SERVICE BULLETIN AMATEUR RADIO

SUBJECT TS-950S/SD 80 METER SPURIOUS EMISSION	DATE 02/06/91
---	-------------------------

Some TS-950SD owners have reported a transmit spurious emission between 3.500MHz and 3.520MHz. This modification will reduce the spurious emission to -65dB.

FIGURE 1

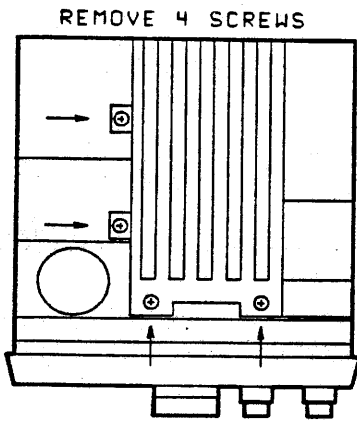
1. Disconnect the power cord and antenna.
2. Remove the top and bottom covers (18 screws).
3. Open the subchassis to expose the PLL board (Figures 1-3). To open the subchassis remove 4 top screws, remove 3 back panel screws, and unplug the RX ANT OUT and DRIVE IN connectors.
4. Replace the four VCO shield plate screws with the type listed above. Figure 3
5. Close the subchassis and secure it with the screws removed in step 3.
6. Locate the A.F. board on the bottom of the transceiver. Figure 4
7. Remove the board's mounting screws and disconnect the necessary connectors to expose the bottom of the board.
8. Locate the foil pattern area shown in Figure 5. This area is below IC11.
9. Cut the foil pattern and add the components shown in Figure 6.
10. Assemble the transceiver. Remember to plug in the two connectors on the back panel.
